# CITY OF ALBUQUERQUE

RE: **Lot 17 Block 8 Unit 18 SAD 228**  
**6628 Sujeto Rd. NW**  
**Grading and Drainage Plan**  
**Engineers Stamp Date 6/13/2024 (D10D003K17)**

Based upon the information provided in your submittal received 6/14/2024, this plan is approved for Grading Permit.

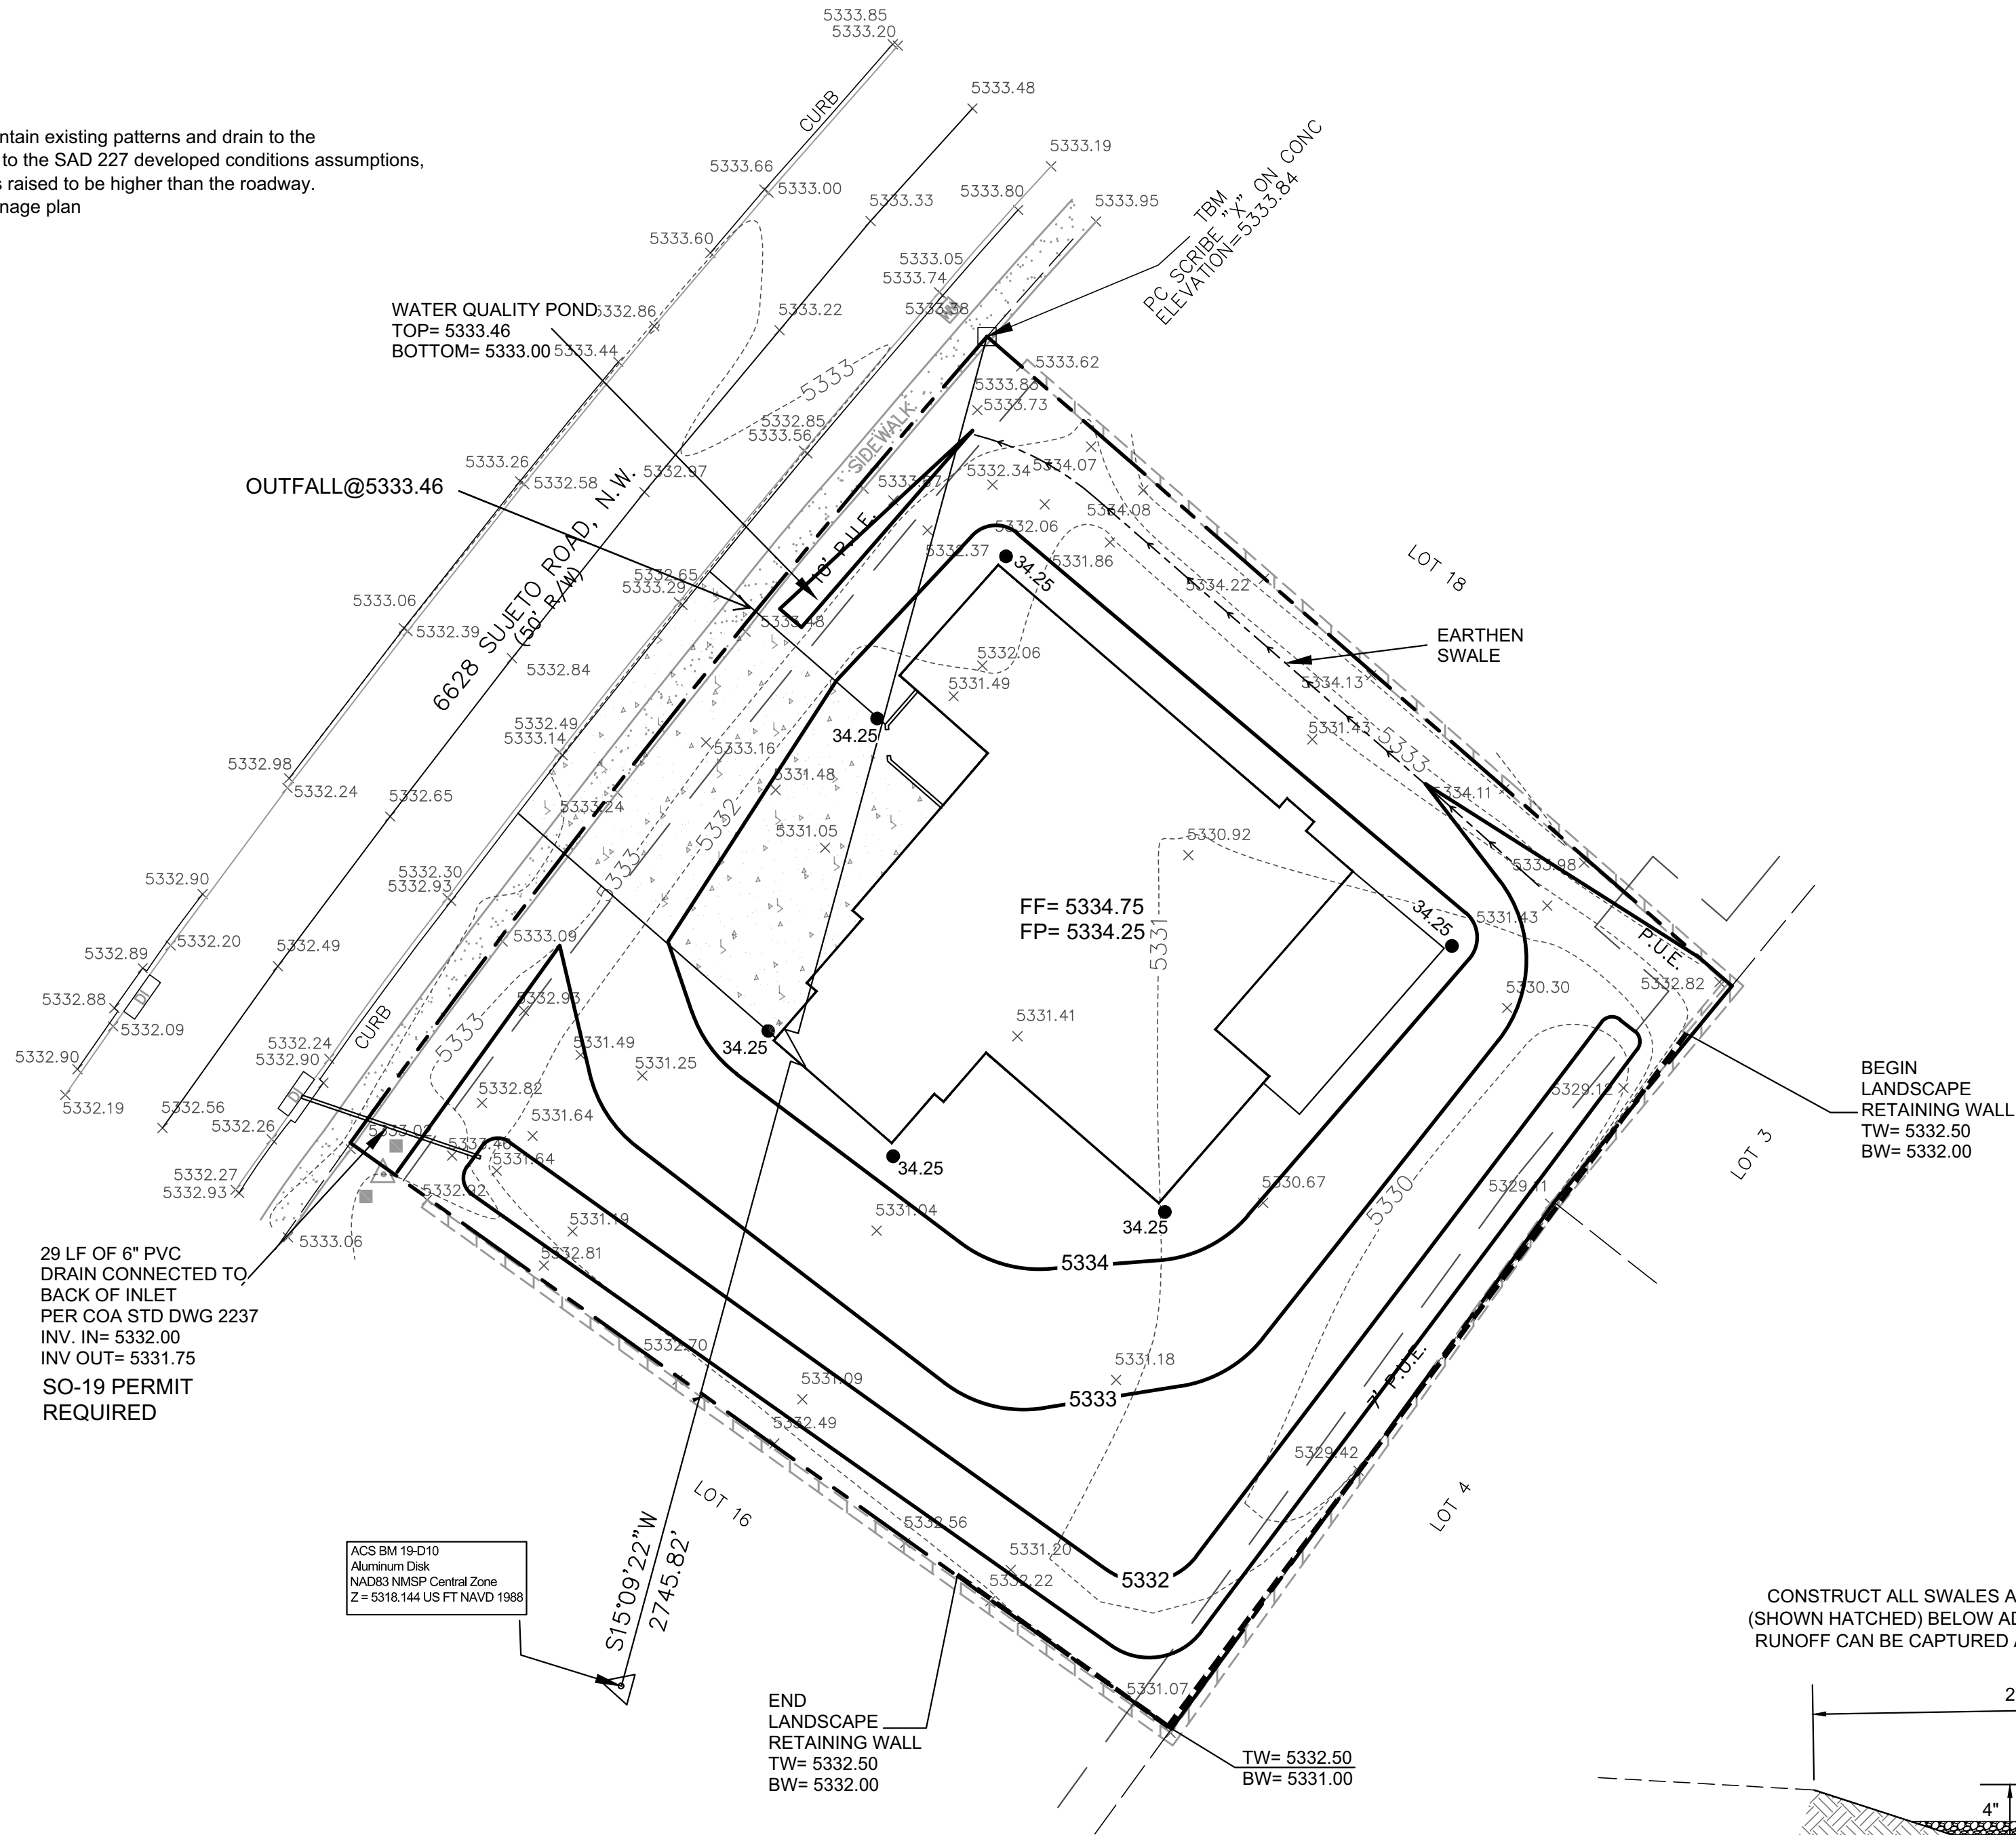
**Prior to Building permit approval a Pad Certification will be required, provided by the Engineer or a registered Land Surveyor.**

**Advise the owner contractor not to use dirt as a ramp to climb the curb, use lumber or crusher fines for this purpose.**

Reiterate to the Owner/Contractor that a separate permit for a garden/retaining wall must be obtained with the approved G&D plan and Pad Certification. Also, if a swimming pool is to be placed the grading and drainage plan will change and will need to be resubmitted.

**Prior to Certificate of Occupancy release, Engineer Certification per the DPM checklist is required.**
